TO:	Susan Pelz Florida Department of Environmental Protection – Southwest District Office 13051 North Telecom Parkway Temple Terrace, Florida 33637	DATE	March 31, 2010
		JOB. NO.	08449-030-04 Task 2100
		RE:	Southeast County Landfill Minor Permit Modification Application - Leachate Management Plan Updates – Response to FDEP Request for Additional Information

**LEACHATE MANAGEMENT PLAN UPDATES  
RESPONSE TO FDEP REQUEST  
FOR ADDITIONAL INFORMATION  
PHASES I-VI AND THE  
CAPACITY EXPANSION AREA  
(SECTIONS 7, 8, AND 9)  
SOUTHEAST COUNTY LANDFILL  
HILLSBOROUGH COUNTY, FLORIDA**

RE: Hillsborough County Southeast County Landfill  
Leachate Management Plan, Phases I-VI and Sections 7, 8 and 9  
Pending Permit Modification No. 35435-017-SO/MM to Permit No. 35435-014-SO/01  
Jones Edmunds Project No.: 08449-030-04 Task 2100

This letter addresses comments received from the Florida Department of Environmental Protection dated **February 25, 2010**. Each of the Department's comments is presented below in *italics*, followed by the response in **bold** type.

CLIENT: **HILLSBOROUGH COUNTY SOLID WASTE MANAGEMENT DEPARTMENT**

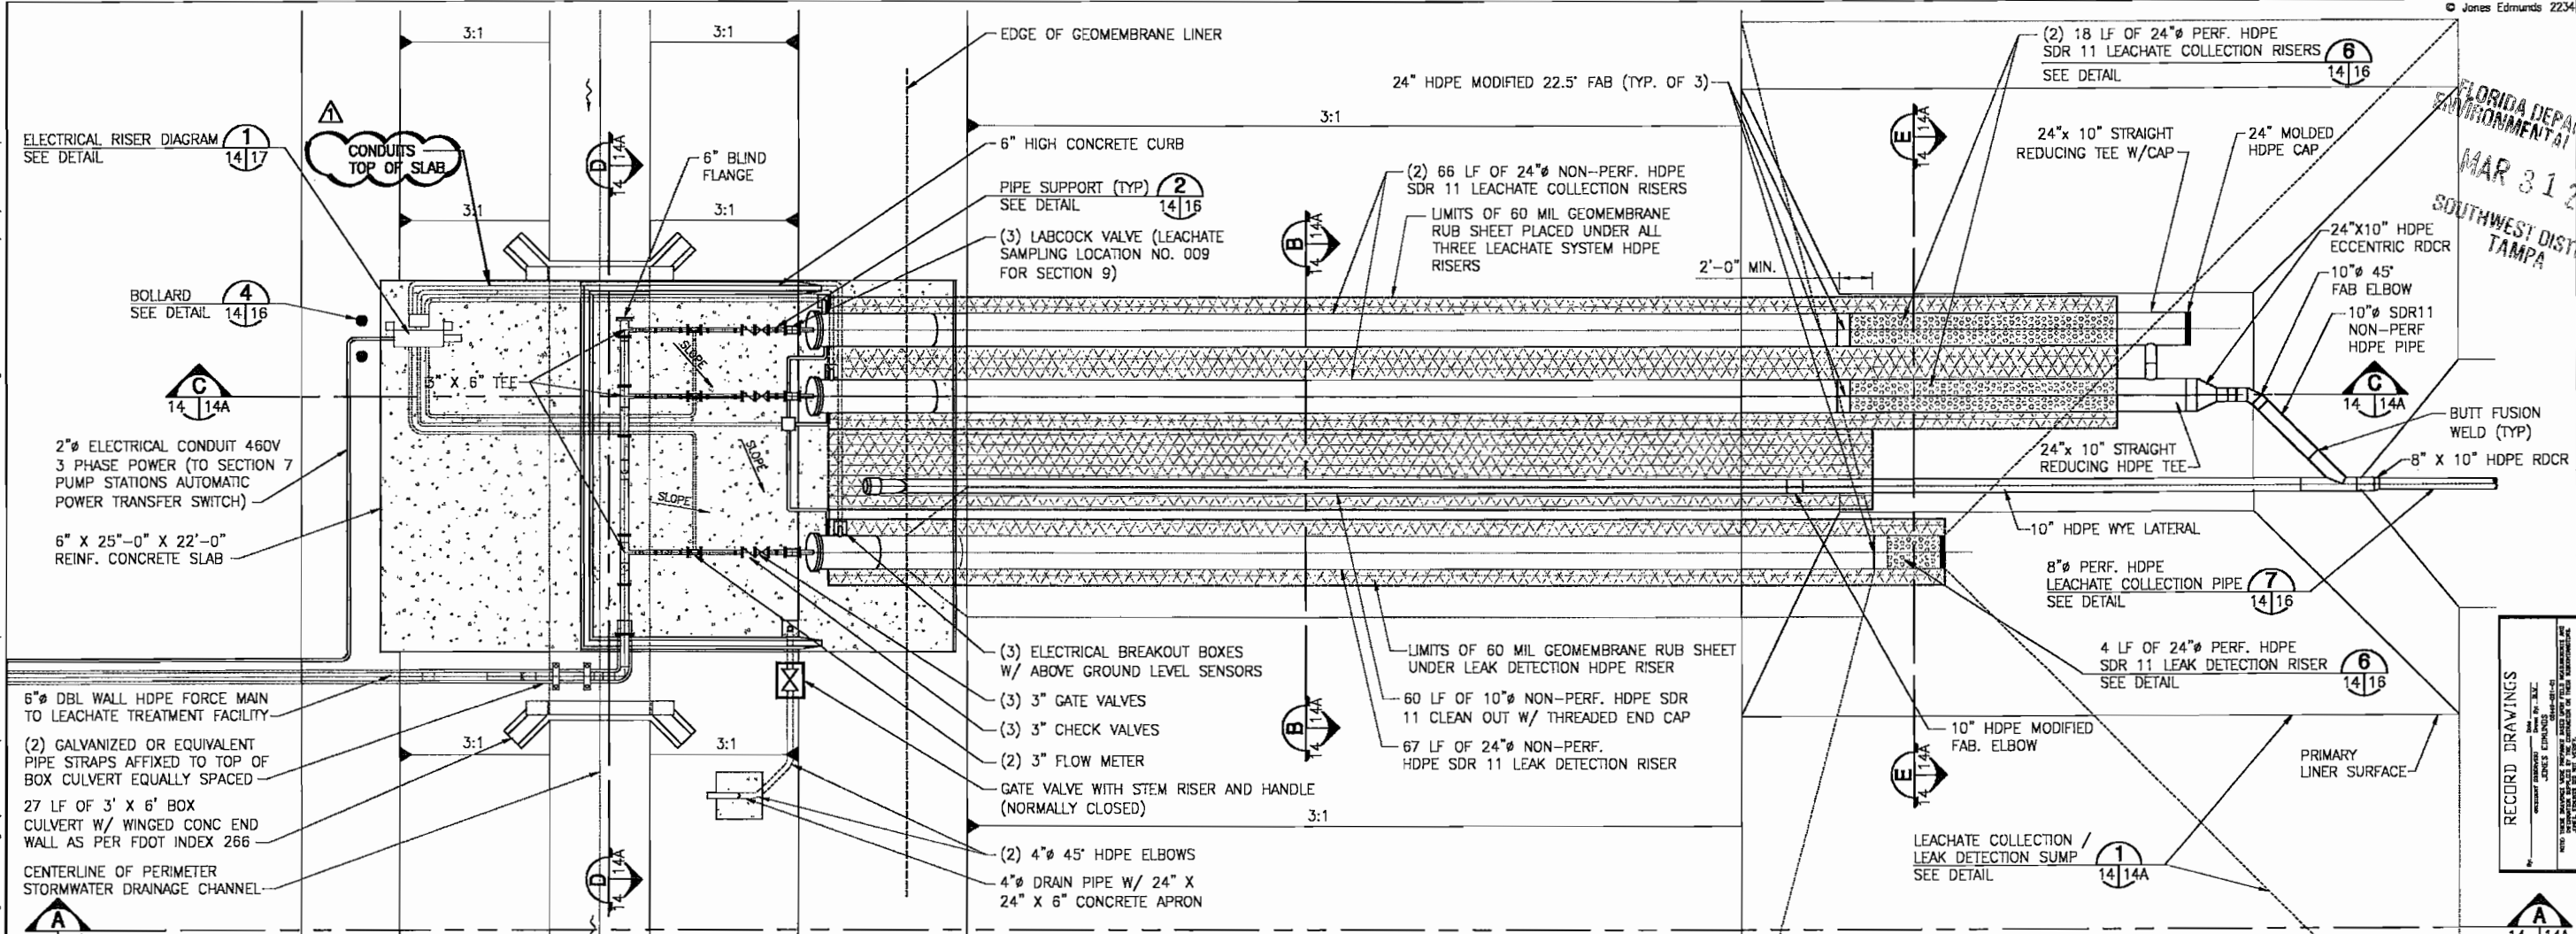
*Comment 3: Section 4.0. Please include containment structure details for each of the pump stations described in this section.*

**Response 3:** The containment structure as-built drawings for each pump station are provided in separate documents from the LMP included as part of record drawings and construction completion correspondence. For the Department's convenience, the as-built drawings for the containment structures at Pump Station A/B, Section 7, Section 9, the Main Leachate Pump Station (MLPS), and the Temporary Pump Station 6 are provided in Attachment 2, but have not been included in the LMP because the details are not necessary for operation.

**LEACHATE AND EFFLUENT/LEACHATE STORAGE TANK SCHEMATIC**

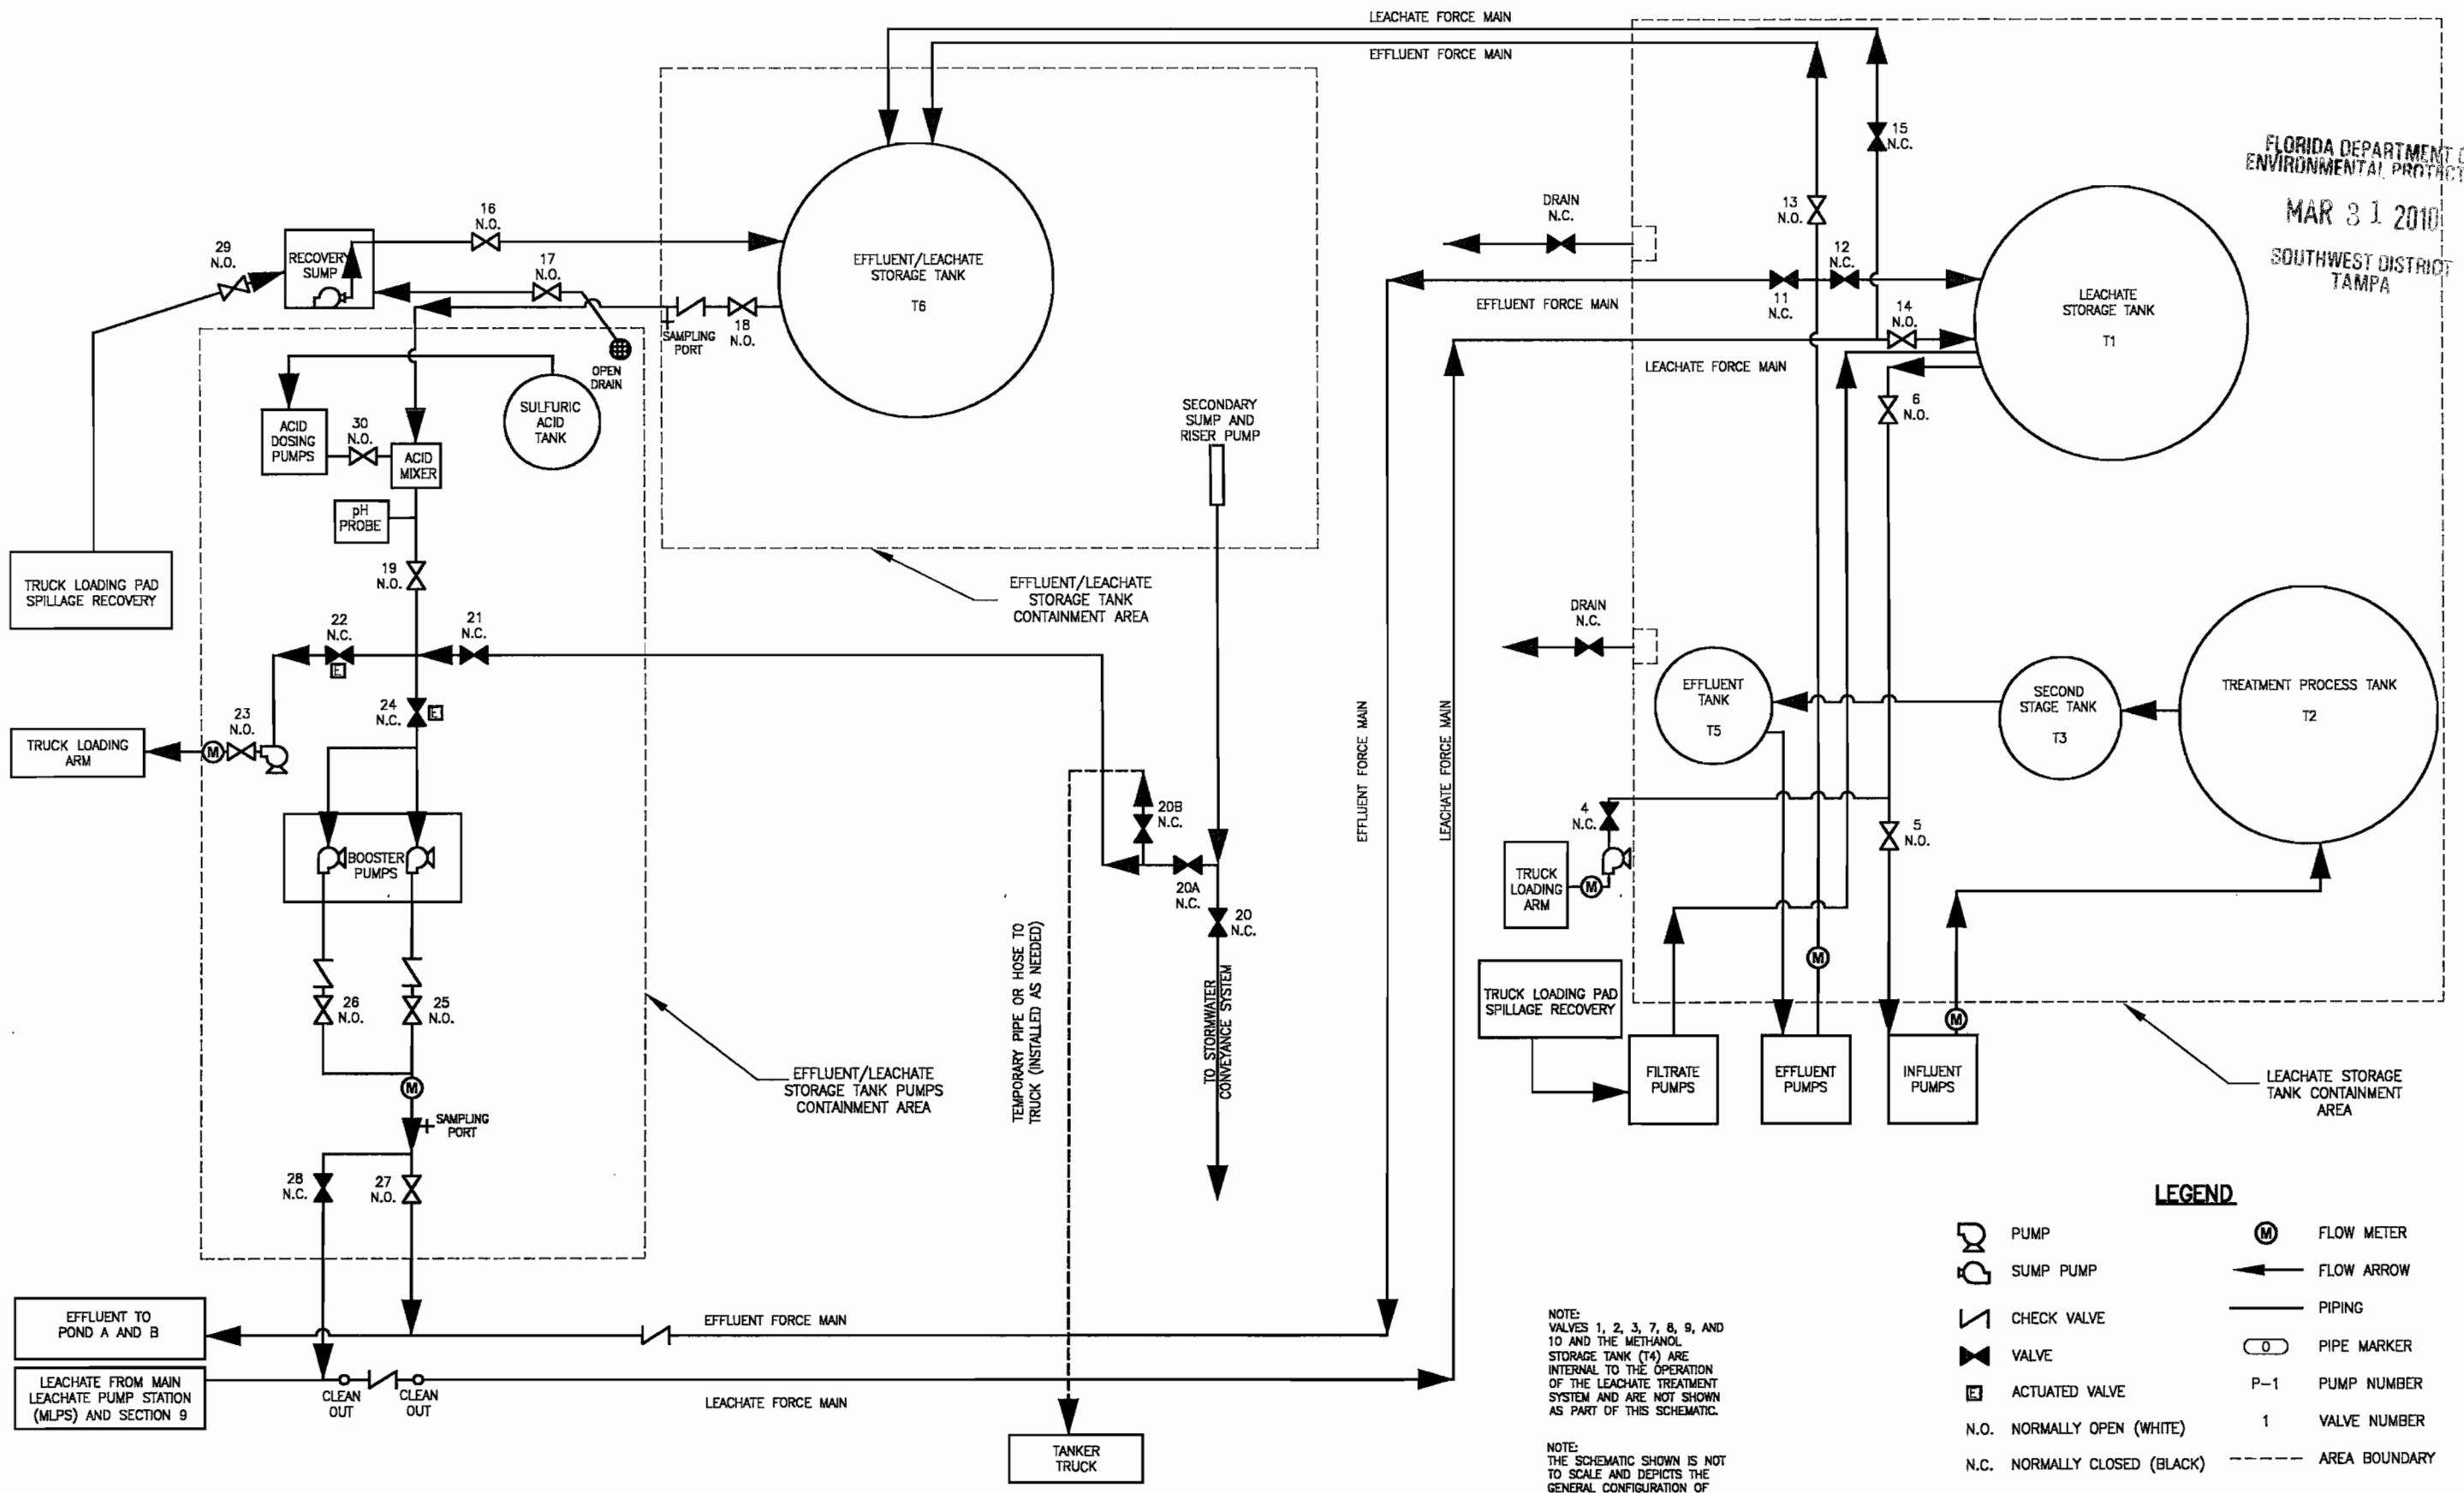
*Comment 6: Appendix B, Leachate and Effluent/Leachate Storage Tank Schematic. Please include leachate from Section 9 on this schematic.*

**Response 6:** The Leachate and Effluent/Leachate Storage Tank Schematic has been revised to indicate that leachate from Section 9 is included in the same force main as the Main Leachate Pump Station to the LTRF. The revised schematic is provided in Attachment 5.
